## PRODUCT BULLETIN #PB2045\_(Rev. B)

**DATE:** April 27, 2001  
**SUBJECT:** Improvement  
**EFFECTIVE:** Immediately (ECR #13046)

**REF: 30ARTUL-17**  
**AR Series Air Ride Suspension**

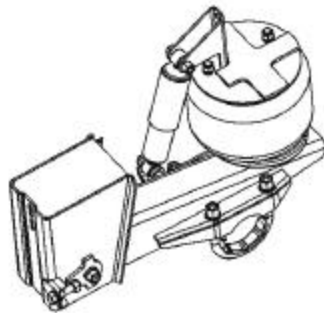
The jounce and rebound travel have been improved to offer better jounce. This is effective for both the 30ARTUL-17A and the 30ARTUL-17S.

#### COMPONENT CHANGES:

1) The front hanger is now longer.

2) The air spring plate is now shorter.

#### NEW SPECS

JOUNCE (UP) 4-1/16" (103 mm)

REBOUND (DOWN) 3-1/2" (89 mm)
